Subject: Submission of NAC Responses to the NRC's Request for Additional Information to NAC Amendment Request for Certificate of Compliance (CoC) No. 9225 for the NAC-LWT Cask to Incorporate AECL NRU/NRX fuel as Authorized Content

Docket No. 71-9225                      TAC No. L24697

# NRU/NRX RAI Response Package

**FOR REVIEW OF THE CERTIFICATE OF COMPLIANCE NO. 9225,  
REVISION FOR THE MODEL NO. NAC-LWT PACKAGE TO  
INCORPORATE NRU/NRX FUEL**

Figure 6.7.2-5 MCNP NRU Fuel in Fuel Tube Cross-Section (No Flow Tube)

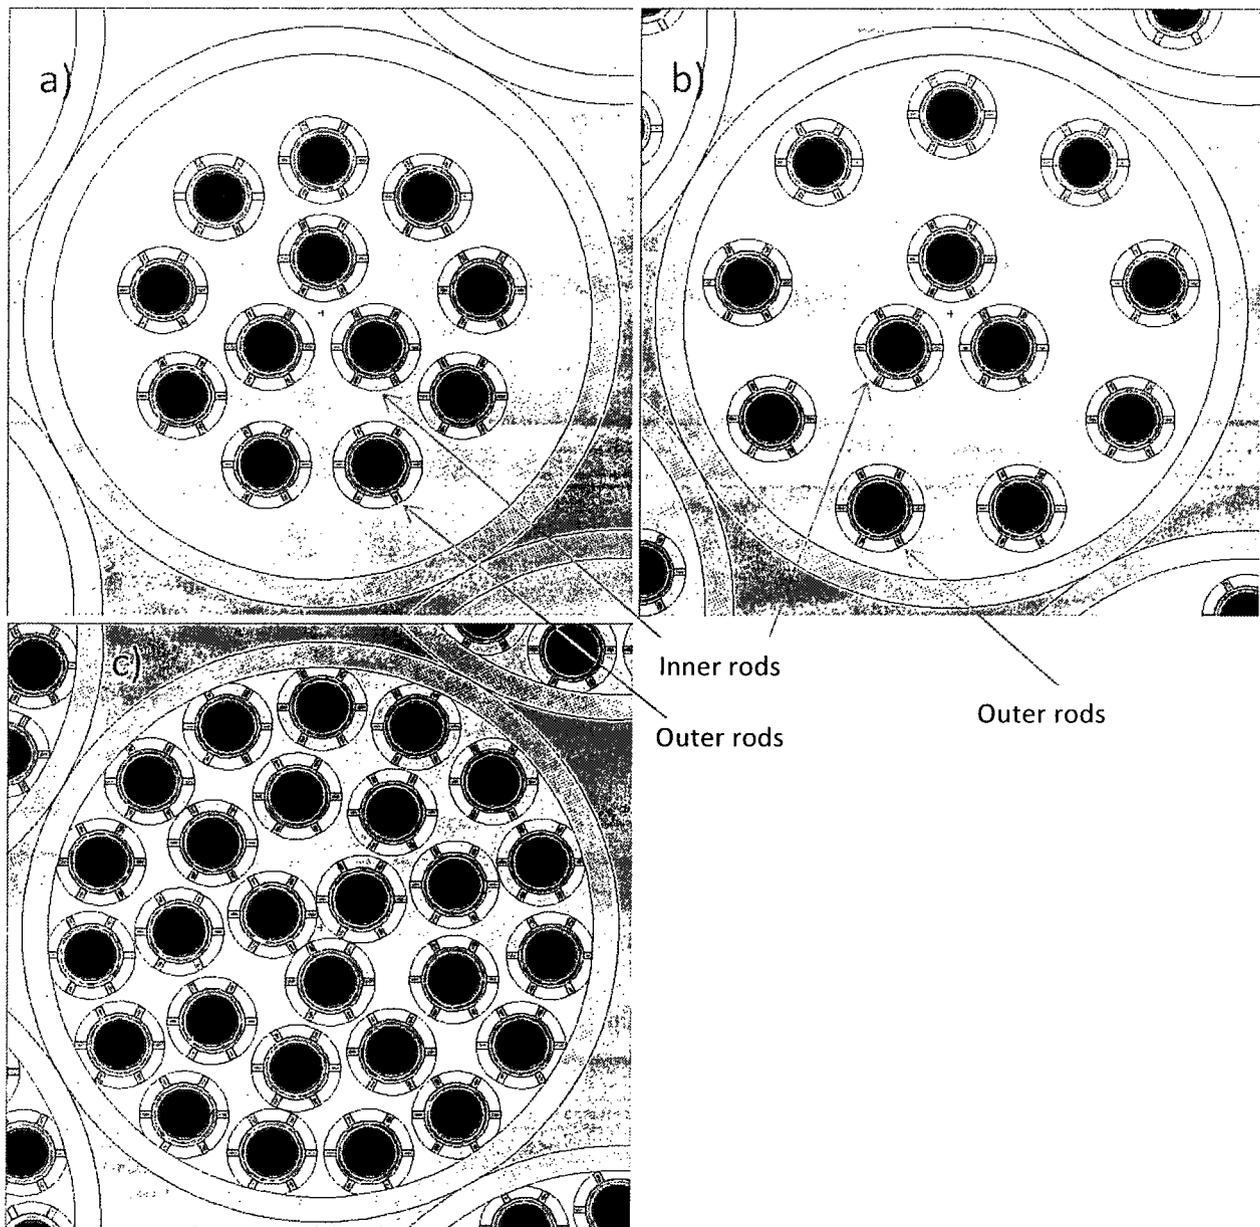
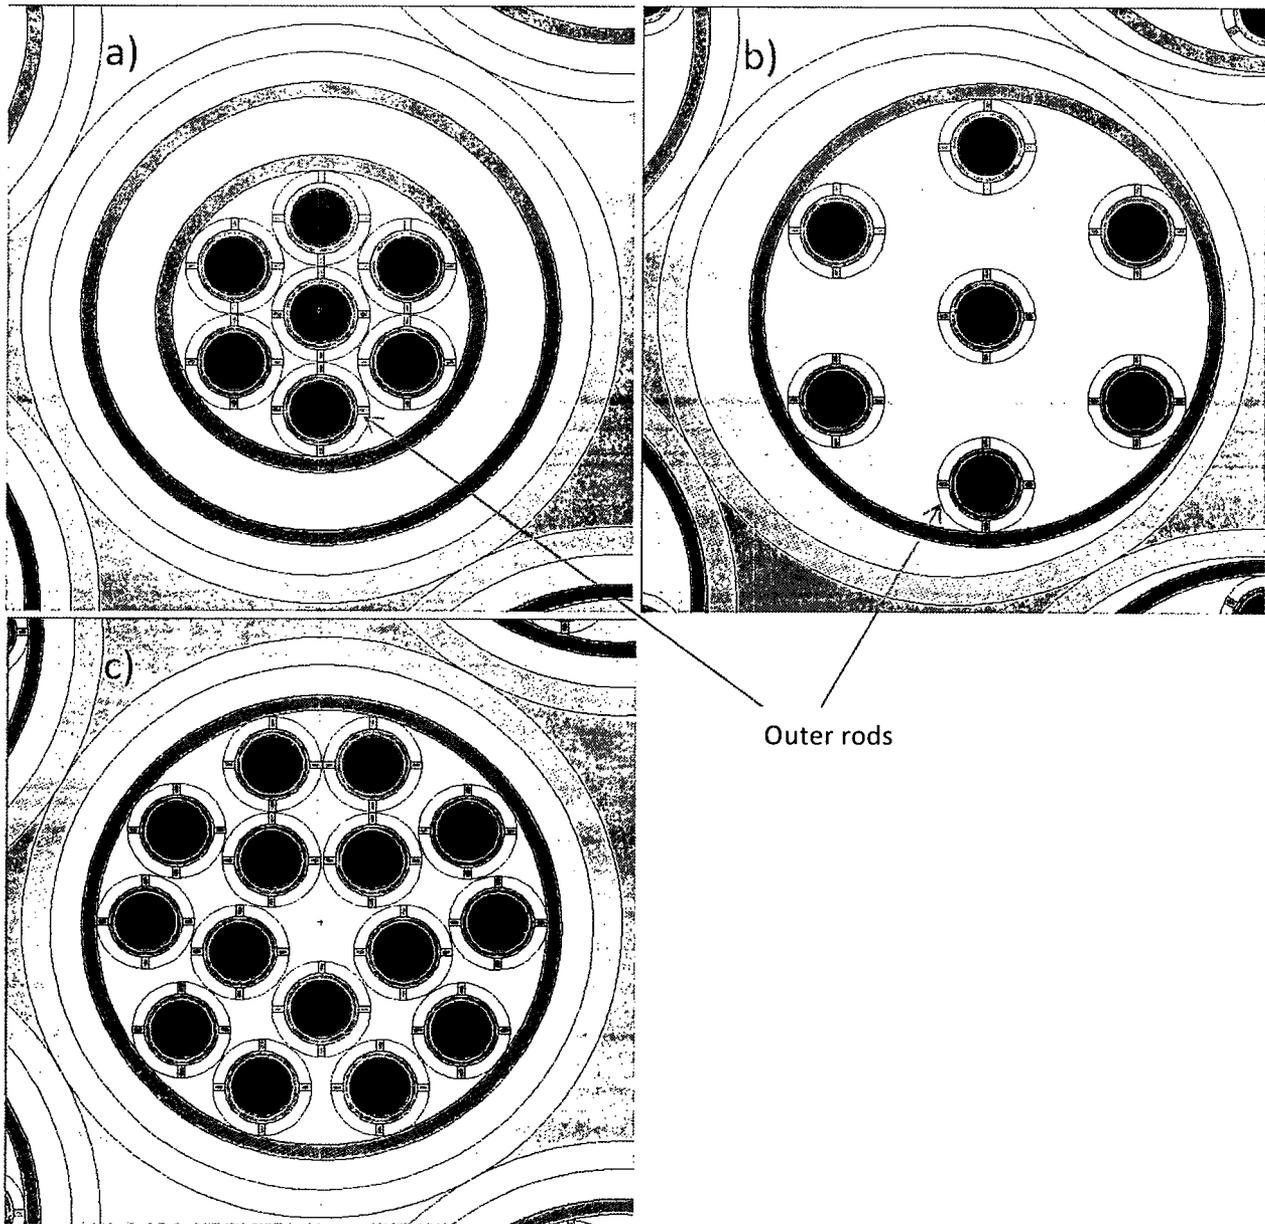
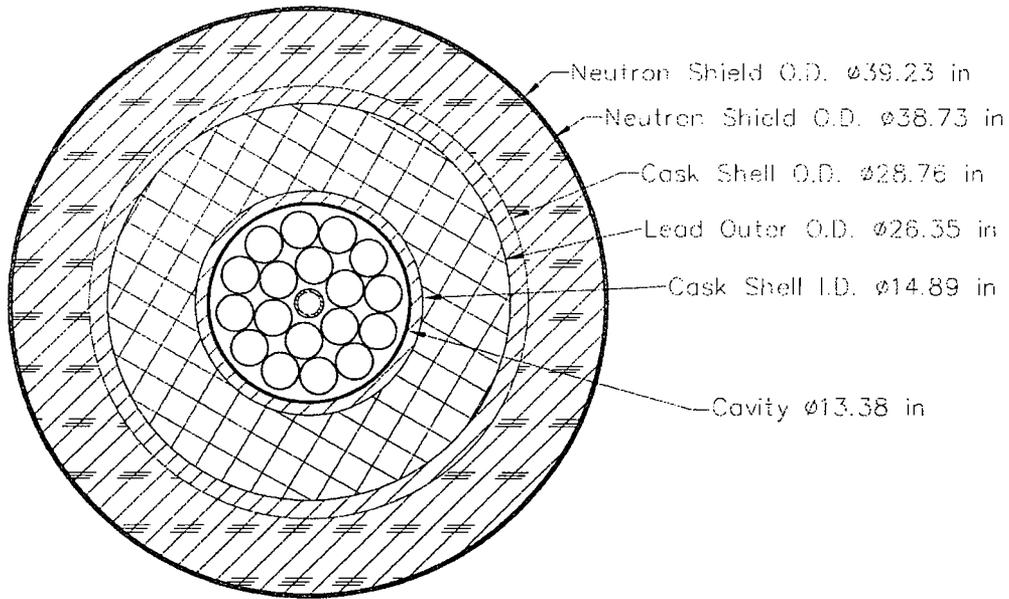
- 6-8 Clarify what is meant by "*radial maximum shift of the outer rods*" in the section 6.7.2.4, second paragraph. Additionally, clarify the legend of Figures 6.7.2-12 and 6.7.2-13.

The staff does not understand this explanation of the most reactive fuel pitch and the legends are not clear in terms of what they are supposed to represent.

SAR Section 6.7.2.4 is revised to include additional description/explanation of the modeled geometry. The added text links Figure 6.7.2-5 and Figure 6.7.2-6, which contain illustrations of the rod geometries. The illustrations are updated to point out inner/outer rod locations.

“The results from the models presented in Figures 6.7.2-5 and 6.7.2-6 are shown in Figures 6.7.2-12 and 6.7.2-13, respectively. The model figures are annotated to indicate outer ring fuel locations for NRU and NRX fuel and inner rod locations for the NRU fuel. In the context of the result figures “nominal” refers to the “as-built/in-core” location of the rods. Maximum outer rod location indicates shift of the outer rods away from the tube center to the maximum permitted by tube. Shift along the “x-axis” from 1 to 11 moves the referenced rod type (inner/outer) radially out from the center of the tube, with “1” indicating a close in (minimum radial location) shift and “11” indicating the maximum permitted shift (each shift direction is limited by either adjacent rods or tube/caddy).

- Page 6.7.2-10, Figure 6.7.2-5, added arrows and callouts to figure, and text to note “b”.
- Page 6.7.2-11, Figure 6.7.2-6, added arrows and callout to figure.
